Rayport 430 - 10 Degree Ballast Design
 *Based on ASCE 7-05

Project	VOA - Bayview Heights, ME	Quote No.	10-0790-01	Date	September 2, 2011
Customer	Kenyon Energy	Contact	Tim Ponczek	Phone	(907) 777-0833
Project Address	158 North Street Portland, ME 04101	Wind Speed (mph)	101.0	Building Height (ft)	20.0
Site Condition	No Topographical Features	Exposure Category	C	Module Tilt Angle	10.0
		Importance Factor per ASCE7-05 Section 6.5.5	1.00	Seismic, S₁	0.00
Module Manufacturer	REC	Model Number	REC240PE (BLK)	Output Rating (watts)	240
Module Length (in)	65.55	Module Width (in)	39.02	Module Height (in)	1.50
				Module Weight (lbs)	39.68
				Module Area (sf)	17.76

RE: Roof PV installations – Confirmation of available Roof Load Capacity
158 North Street, Portland, Maine

1:100 10-0790-A1-10B

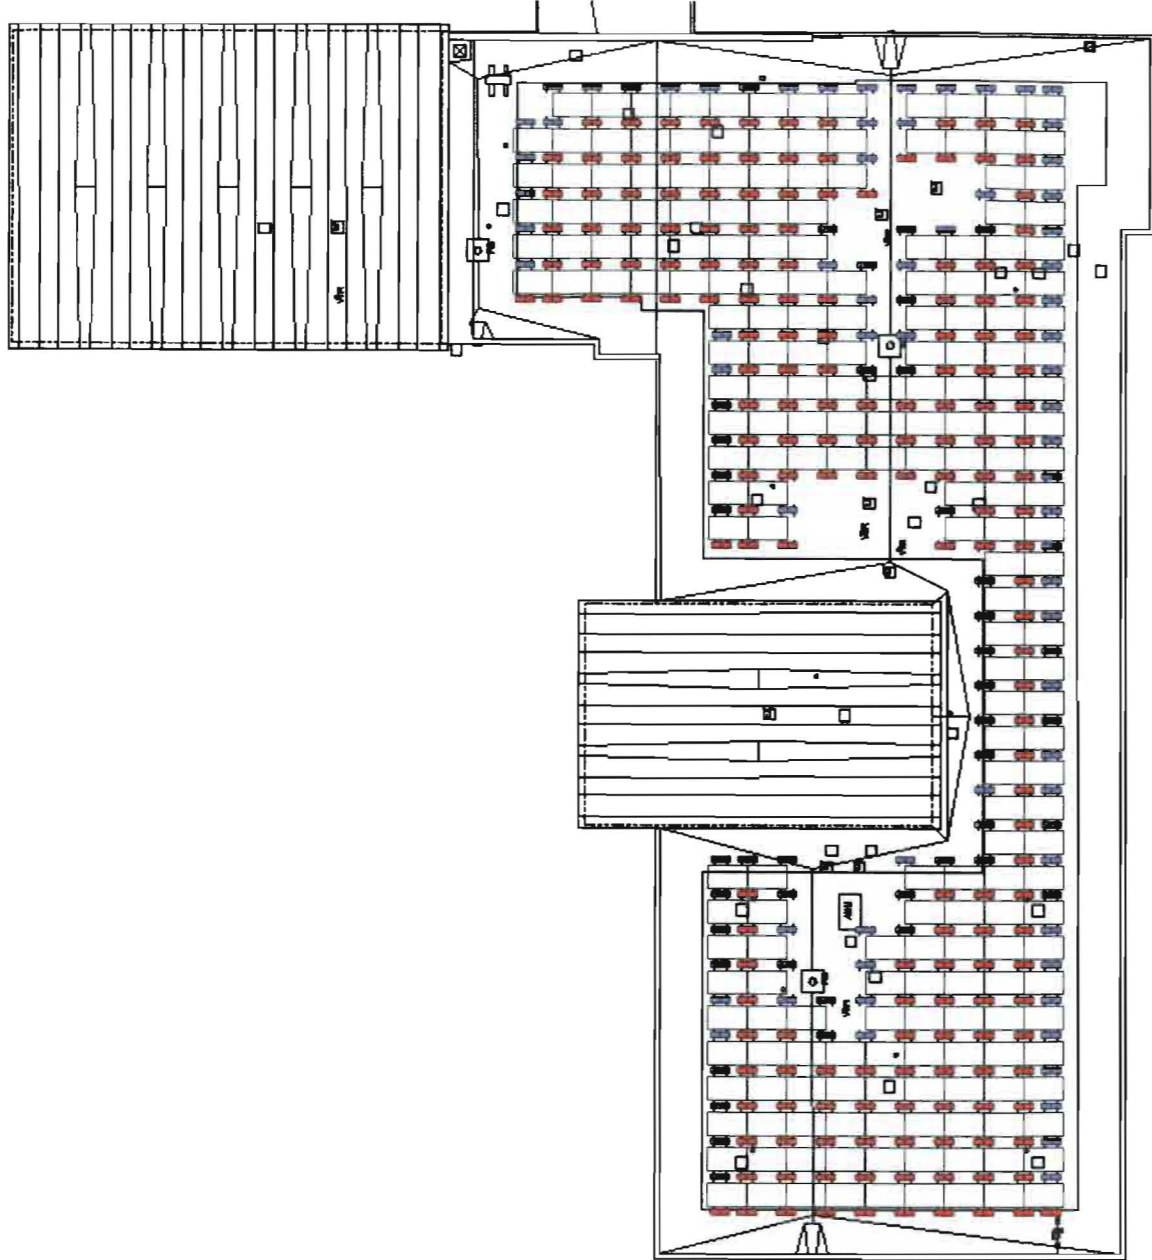
- Plan entitled “Module Layout”, drawing 10-0790-A1-10B as prepared by Applied Energy Technologies of Clinton Township, MI and dated 08/31/11.
- Applied Energy Technologies Cut Sheet for the Rayport Stainless Series Roof Ballast Rack assembly.

The intended PV array will increase the dead load on the roof surface by approximately 8.9 psf over the array field. It is our opinion, that the current plank spans, and provided intermediate support framing/foundation system recently introduced, has sufficient capacity to support the proposed array system.
